PROJECT REFERENCE NO. U-3308	SHEET NO. EC-37/CONST-16
RW SHEET NO.	
ROADWAY DESIGN ENGINEER	HYDRAULICS ENGINEER

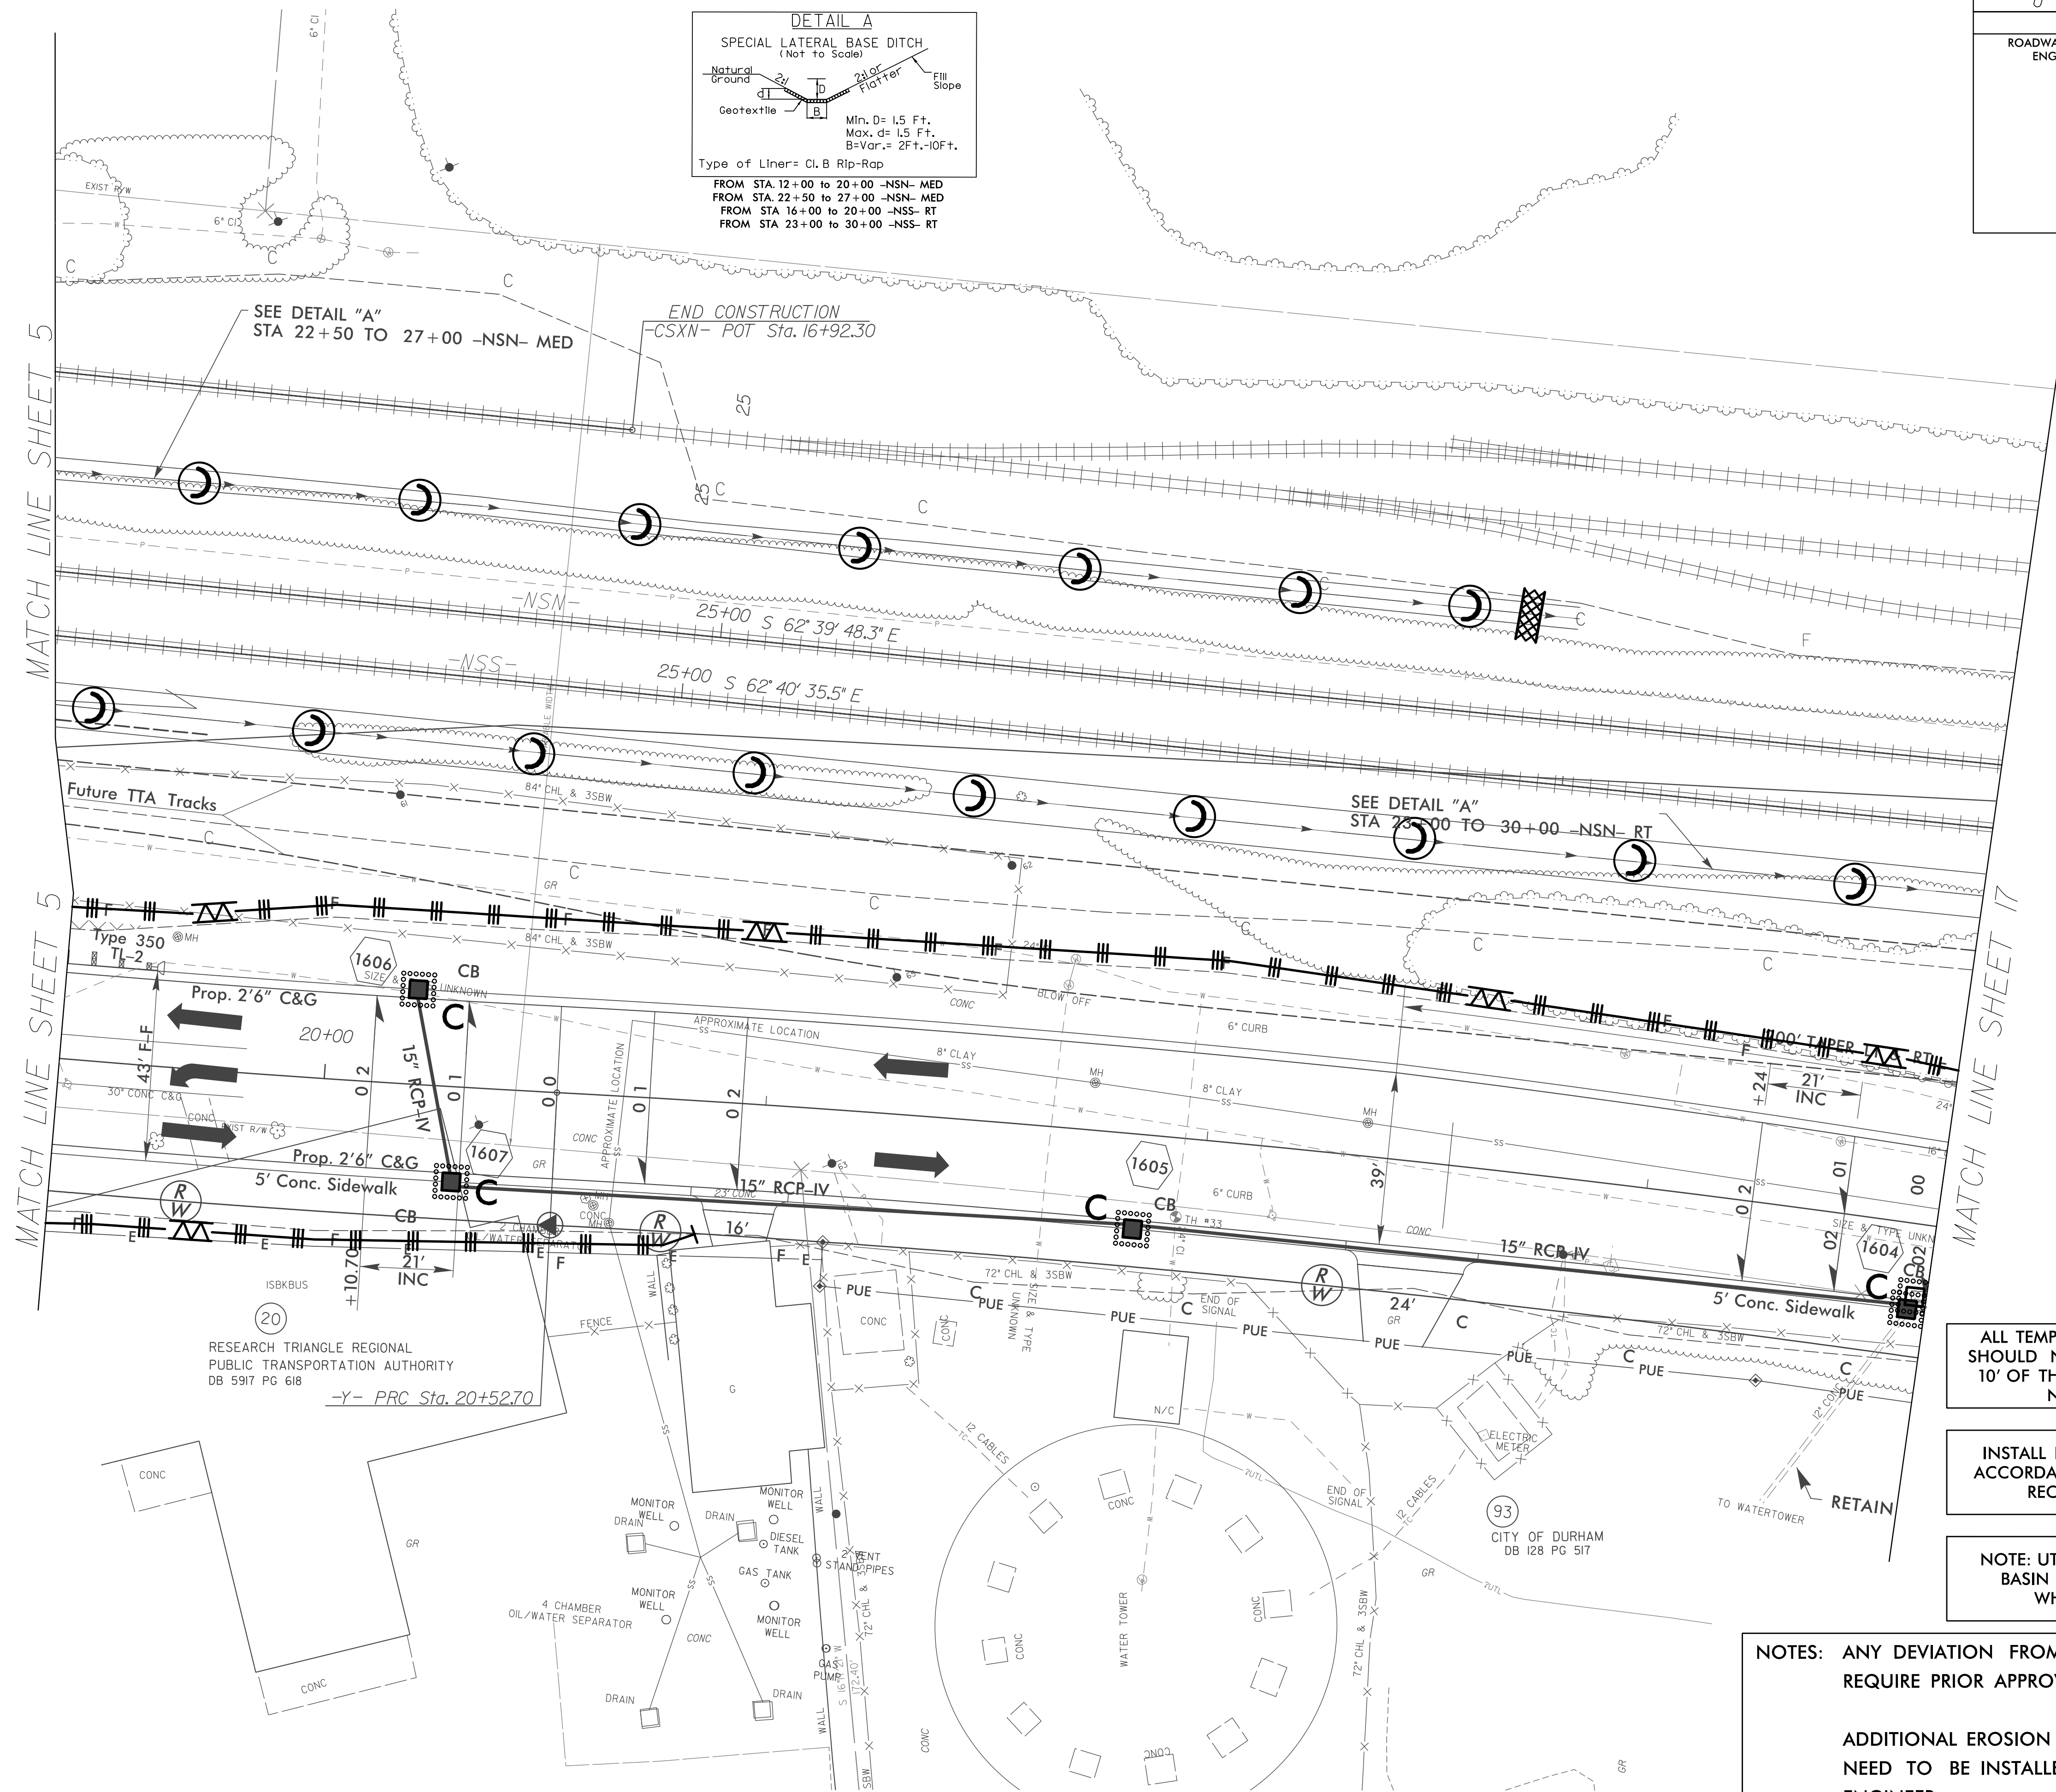
RW Revision 6/1/14 JCL
 Removed Permanent Utility Easement (PUE) from Parcel 20.
